Preliminary/Final Water Quality Plan Amendment 220061410 and Preliminary/Final Forest Conservation Plan SC2017003
 Islamic Society of the Washington Area

MJK Mary Jo Kishter, Senior Planner, Area 3, Maryjo.Kishter@Montgomeryplanning.org 301-495-4701
RAW Richard Weaver, Acting Chief, Area 3, Richard.Weaver@Montgomeryplanning.org 301-495-4544

Staff Report Date: 2/23/17

Attachment A – Impervious Surface Exhibit – Preliminary/Final WQP Amendment

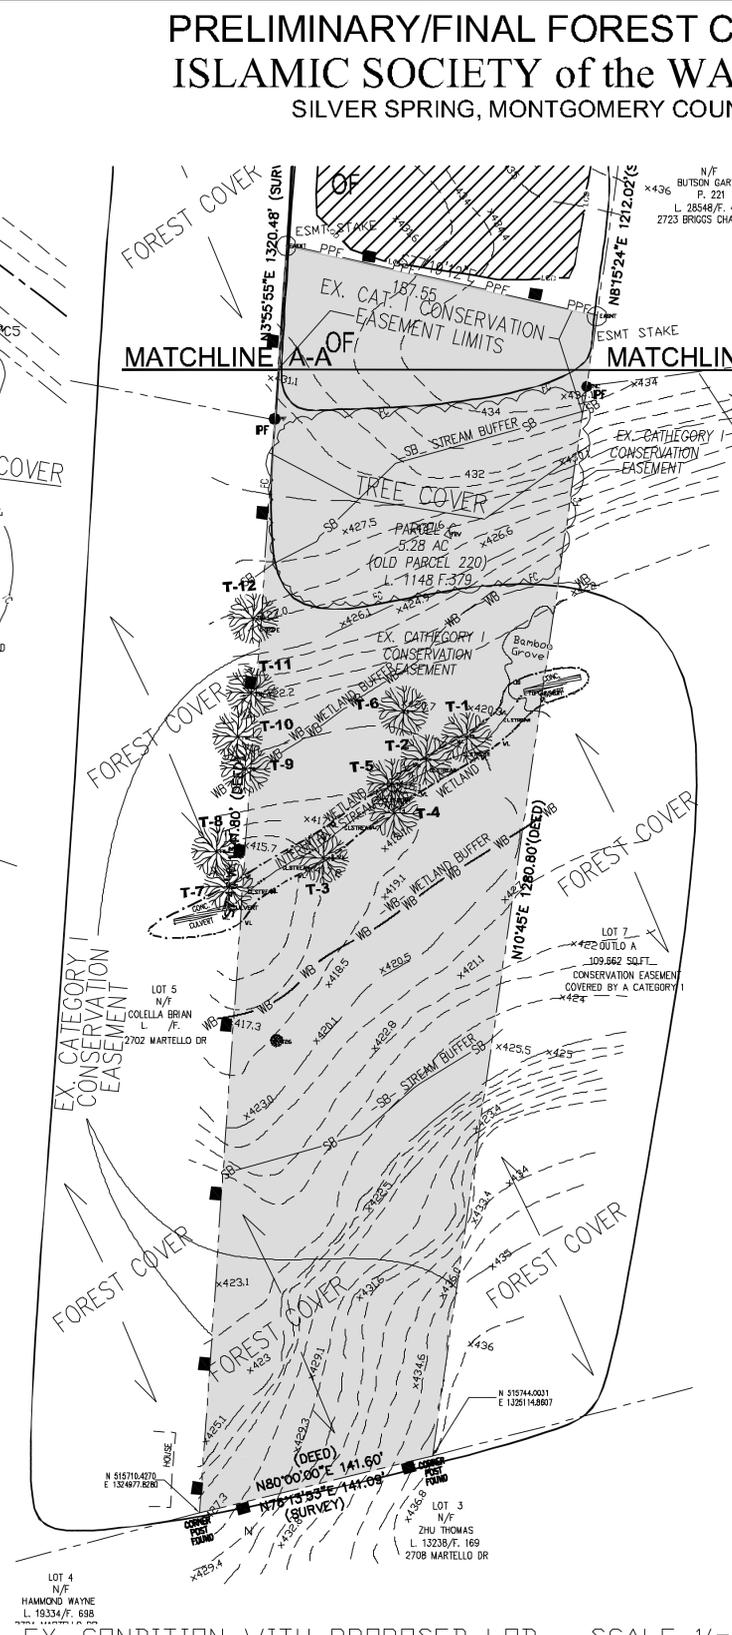
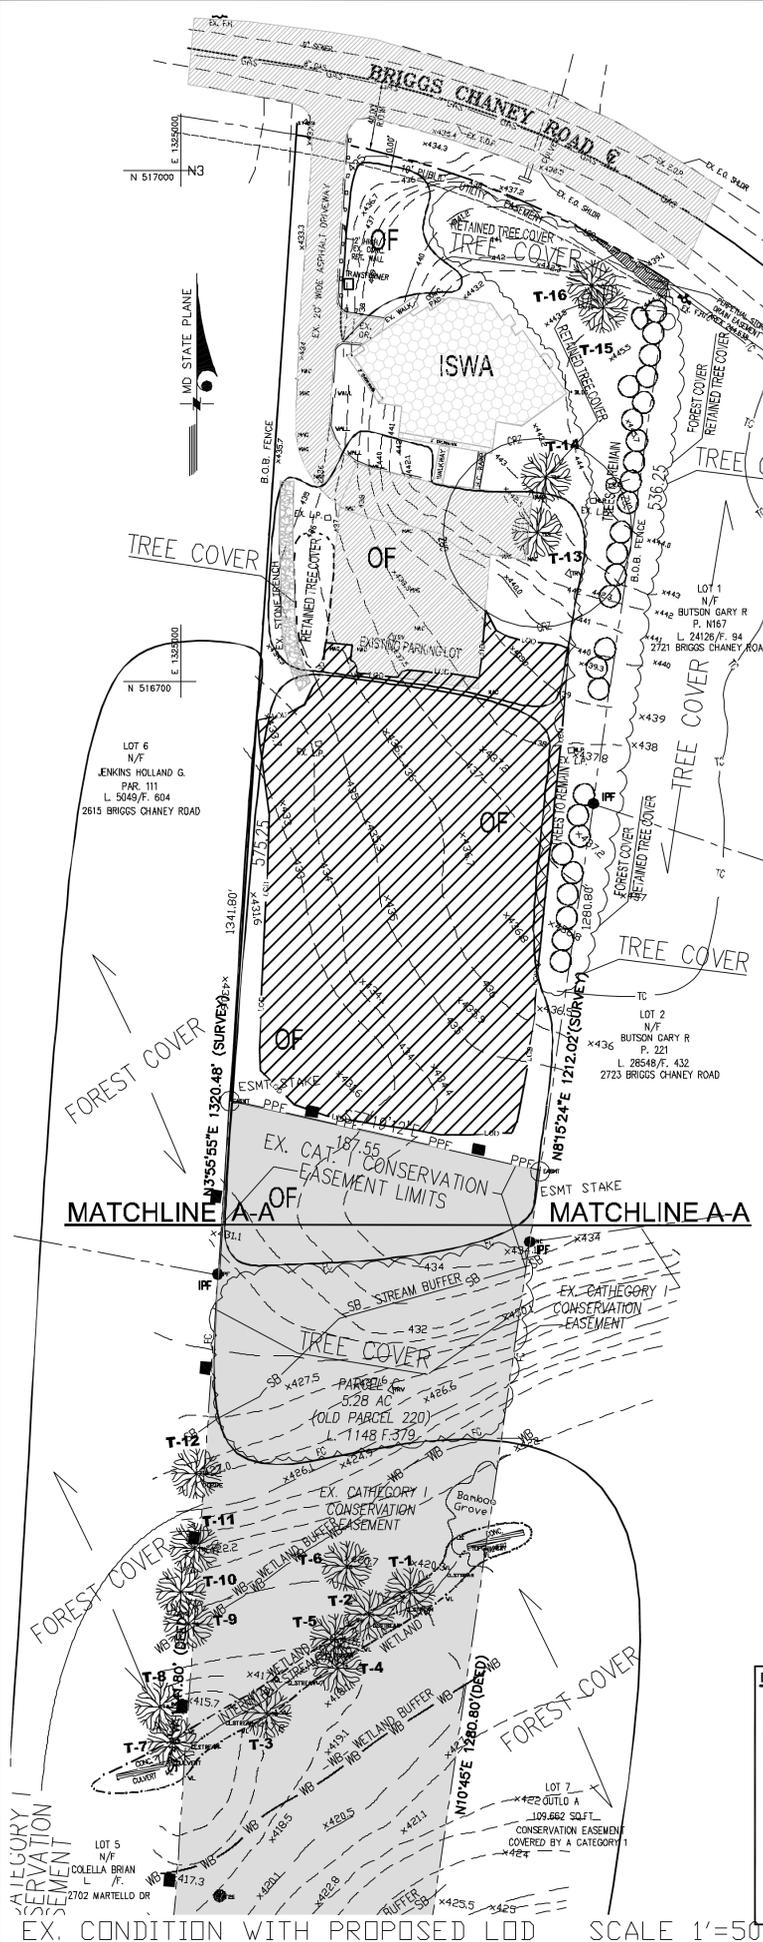
The Application proposes to expand the existing parking lot to include an additional 100 spaces and reconfigure the walkways around the parking lot, requiring the addition of 31,193 square feet of impervious surface on the Property. The proposed additional impervious surface would result in a total of 54,193 square feet of impervious surface, or 23.6 percent of the 5.28-acre Property, as shown on the Impervious Surface Exhibit (Attachment A). The Applicant proposes to mitigate for the additional impervious surface at an offsite location within the same watershed by contributing to the acquisition and restoration of a developed property, including the removal of existing impervious surfaces equal to the amount of impervious surfaces being added to the Subject Property. The mitigation site is recently acquired M-NCPPC parkland located in the Upper Paint Branch Special Protection Area and the Upper Paint Branch Overlay Zone. The park site will be completely restored, planted, and maintained as a conservation park. Approval of the amended Water Quality Plan, as conditioned, would result in a new Impervious Surface Agreement between the Applicant and the Planning Board, limiting impervious surfaces on the Subject Property to 24 percent.

Impervious surface restrictions for development projects in the Upper Paint Branch Special Protection Area (SPA) are set forth in the Overlay Zone for the Upper Paint Branch SPA. As per Chapter 59, Section 4.9.18, the imperviousness for the Application may not exceed 8.0 percent. This Property originally obtained approval of a Preliminary/Final Water Quality Plan in 2006 when the impervious surface limit was 10.0 percent. At that time, the Applicant entered into an Impervious Surface Agreement with the Planning Board limiting their impervious surfaces to 10.0 percent. As previously mentioned, the parking provided under that original approval has proved to be inadequate to meet the needs of the congregation and parking was occurring outside of the previously approved impervious areas. This Application proposes to amend the Preliminary/Final Water Quality Plan to allow the construction of an additional parking lot, requiring 31,193 square feet of additional impervious surfaces on the Property to alleviate the existing parking shortage. The Application results in a total of 54,193 square feet of impervious surface, or 23.6 percent of the 5.28-acre Property.

The Applicant will enter into a new Impervious Surface Agreement with the Planning Board limiting their impervious surfaces to 24.0 percent. The Applicant proposes mitigation for the additional onsite impervious surfaces by removing an equal amount of impervious surface from another property located within the Upper Paint Branch SPA and Overlay Zone. This mitigation approach is similar to what has been allowed for other institutional uses such as Montgomery County Public Schools.

1. Impervious surfaces are limited to no more than 24 percent of the subject property within the SPA as shown on the Impervious Surface Plan Portion of the Preliminary/Final Water Quality Plan.

2. Prior to any demolition, clearing or grading, the Applicant must enter into a revised agreement with the Planning Board to limit impervious surfaces to no more than 24 percent on the subject property and demonstrate conformance to the impervious surface limits.

C-01

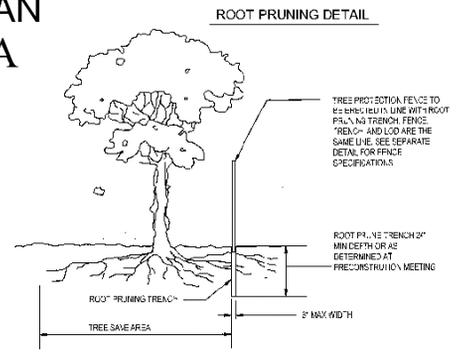
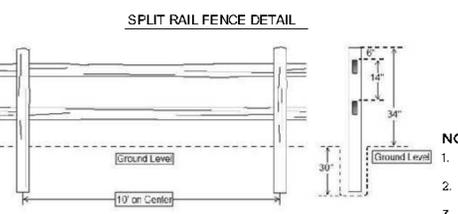
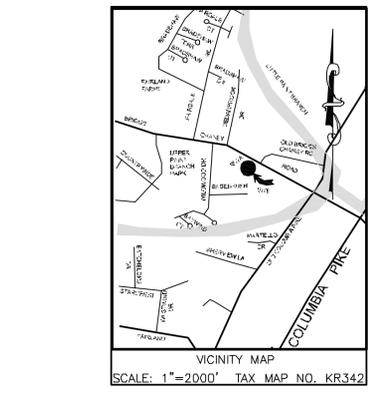
A Preliminary/Final Forest Conservation Plan was submitted for review on August 31, 2016 (Attachment B). The Subject Property contains approximately 2.1 acres of existing forest that is protected along with the onsite stream, wetlands and stream buffer, by an existing Category I conservation easement. There is no disturbance proposed within the forest and there is no forest planting required to expand the parking facility for this Application. Approval of the Forest Conservation Plan, as conditioned, will require that a fence be erected along the northern perimeter of the conservation easement where it abuts the proposed parking lot. In addition, signs identifying the limits of the conservation easement will be installed along the perimeter of the conservation easement, with the exception of the eastern side where it abuts an existing, offsite conservation easement.

The Application meets the requirements of Chapter 22A of the Montgomery County Forest Conservation Law. A Forest Conservation Plan (FCP) (Attachment B) was submitted as required with the review process for a sediment control permit. There are approximately 2.0 acres of forest on the Property currently protected in a Category I conservation easement. The Application proposes to retain all of the forest and there are no impacts proposed to any trees 24" DBH and greater, therefore, no tree variance is required. The Applicant will install permanent fencing along the northern limit of the conservation easement where it abuts the proposed parking lot and permanent signs along the southern and western limits of the easement. The eastern side of the conservation easement is adjacent to an offsite conservation easement.

- B. PRELIMINARY/FINAL FOREST CONSERVATION PLAN NO. SC2017003:** Staff recommends approval, subject to the following conditions:
1. Prior to issuance of the sediment control permit by MCDPS, and at the direction of the M-NCPPC forest conservation inspector, the Applicant must install permanent split rail fencing or equivalent acceptable to M-NCPPC Staff, along the conservation easement boundary where it abuts the onsite parking lot as shown on the approved Preliminary/Final Forest Conservation Plan.

3. The Final Sediment Control Plan must depict the limits of disturbance (LOD) consistent with the LOD on the approved Preliminary/Final Forest Conservation Plan.

4. The Applicant must comply with all tree protection and tree save measures shown on the approved Preliminary/Final Forest Conservation Plan. Tree save measures not specified on the approved Preliminary/Final Forest Conservation Plan may be required by the M-NCPPC forest conservation inspector.
